HISTORIC PRESERVATION COMMISSION

APRIL 22, 2021

PLANNING AND INSPECTIONS DEPARTMENT STAFF REPORT

To: Historic Preservation Commission
From: Peter Hughes, Senior Planner
CC: Darryn Burich, Planning and Inspections Director
Kelly Brown, Administrative Specialist
Date: April 12, 2021
Subject: Major COA Request for 1 Carolina Vista (future address to be determined)

EXHIBIT G

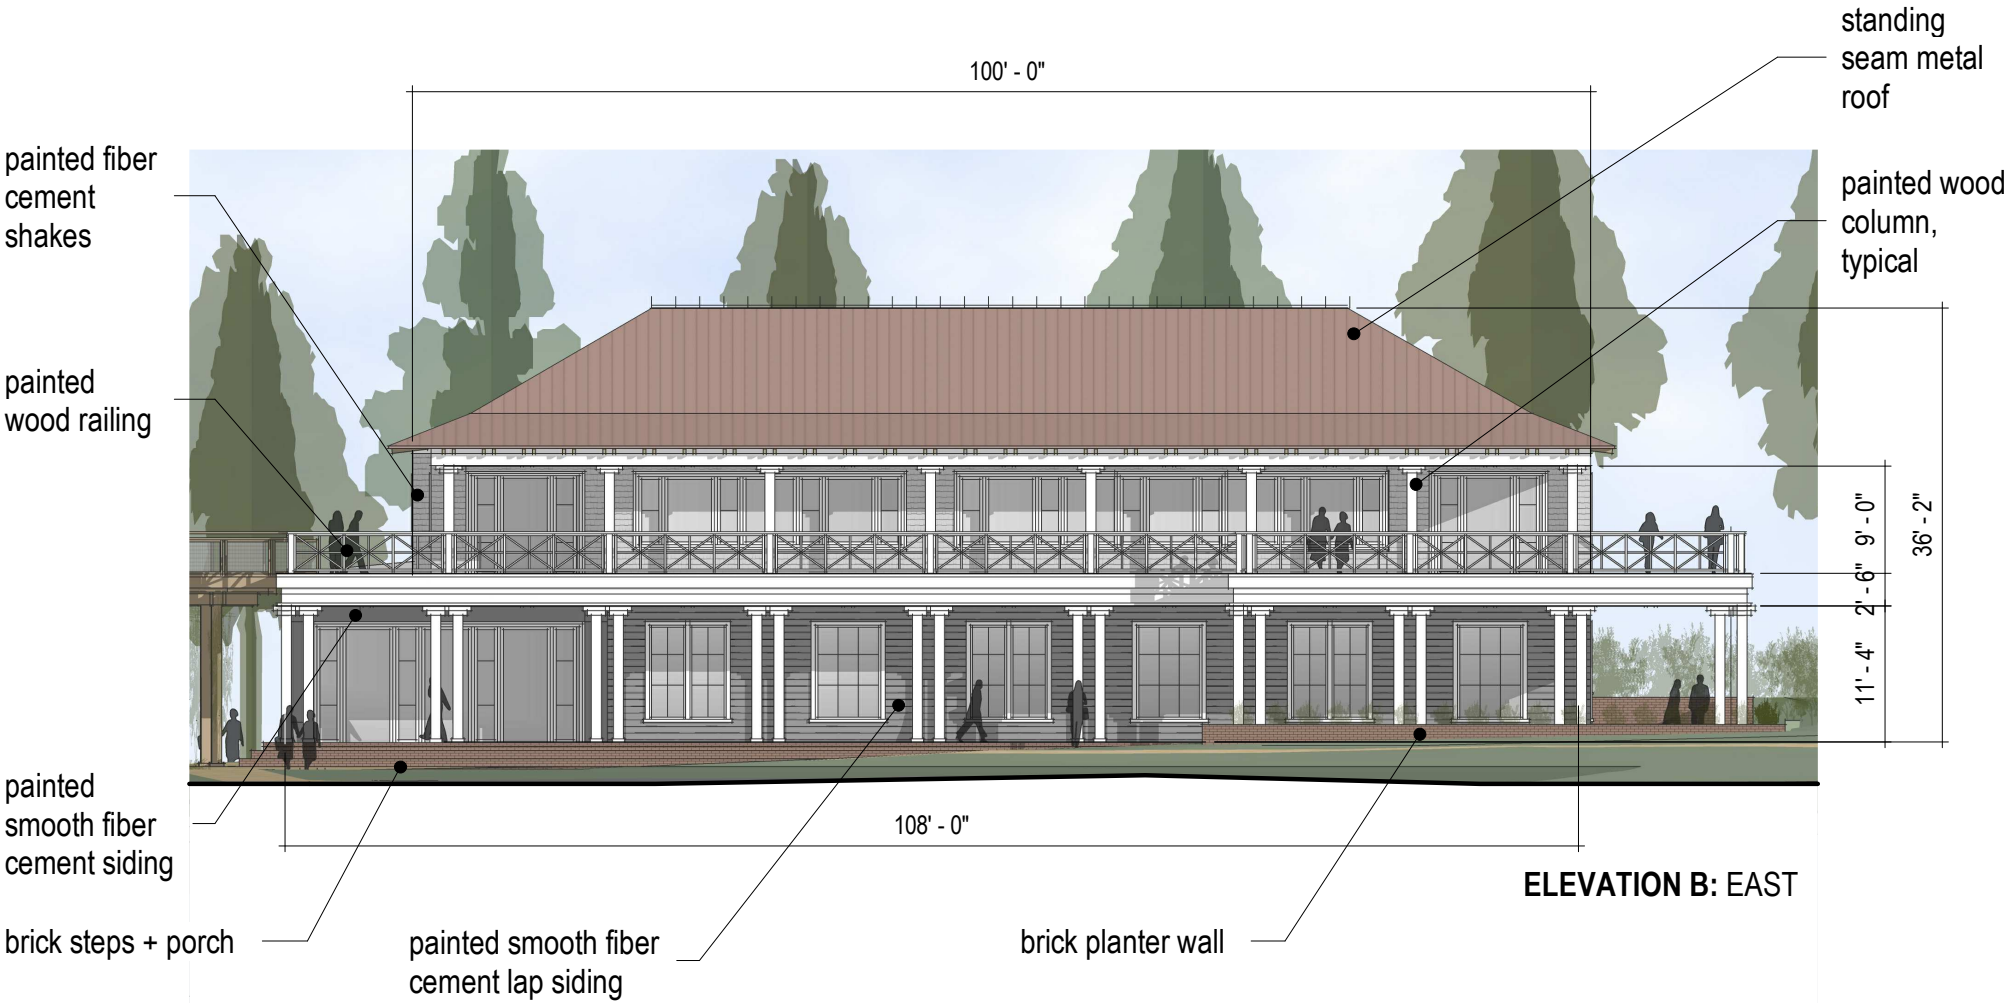
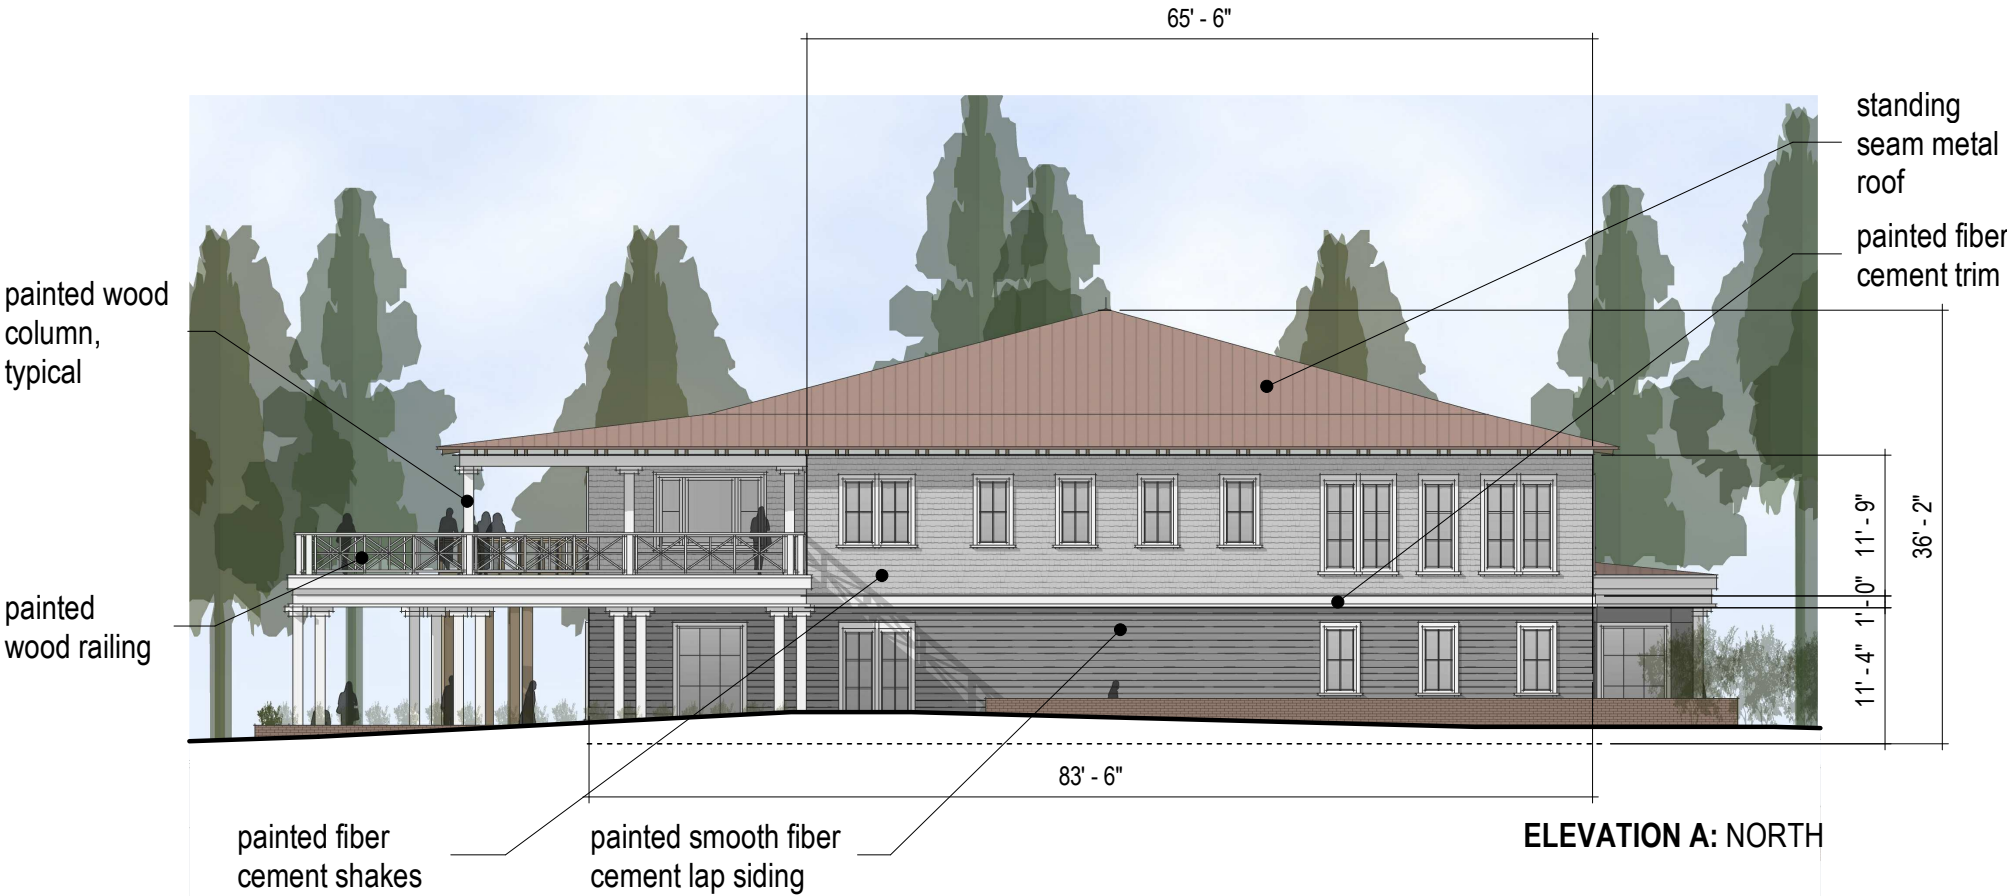
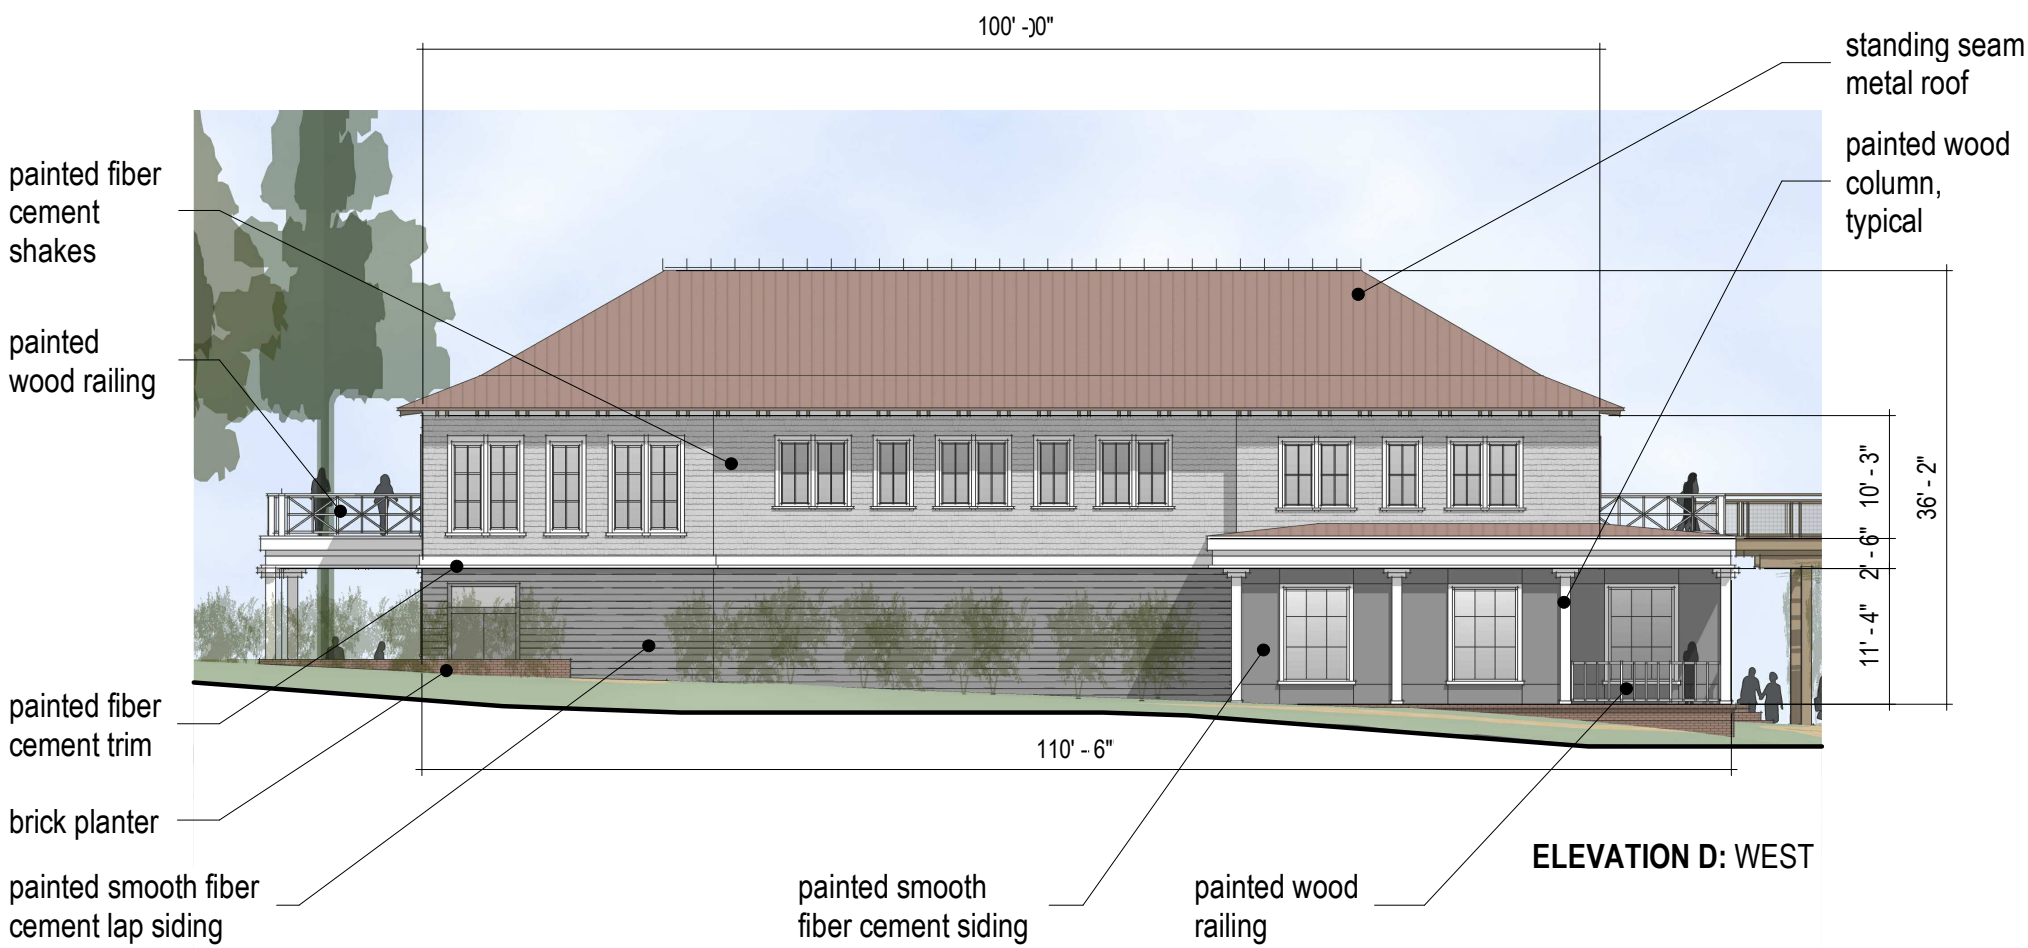
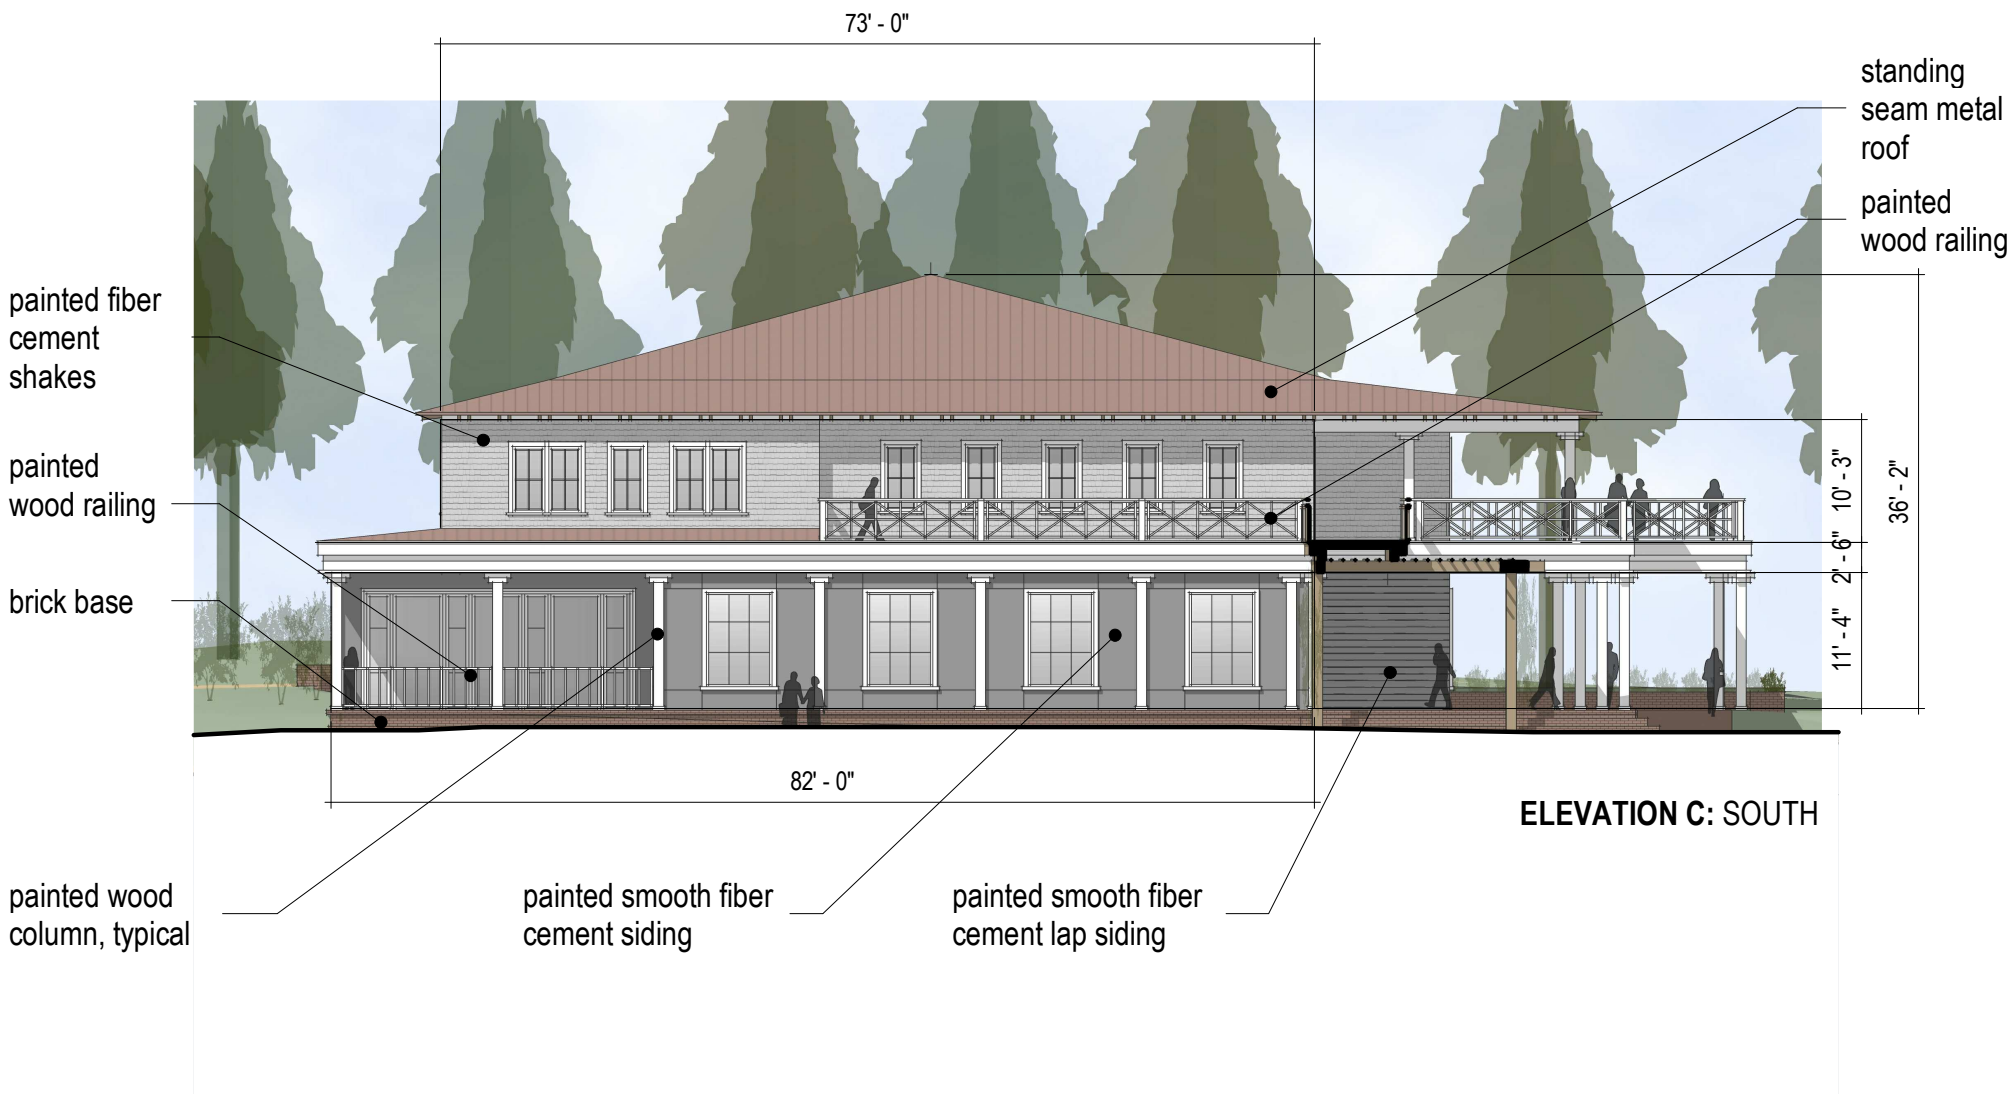
The elevations indicate that the main USGA building will feature dormers. Dormer windows are featured on multiple commercial structures, throughout the Historic District such as the Harvard Building and Holly Inn. The inclusion of dormers on the USGA assists with wayfinding and establishes a unique architectural detail that helps distinguish the two structures from one another.

The applicant is proposing construction of a two story walk way that connects the USGA building with the Museum structure. This architectural detail would be a distinct characteristic to the site and would be a unique design element within the Historic District.
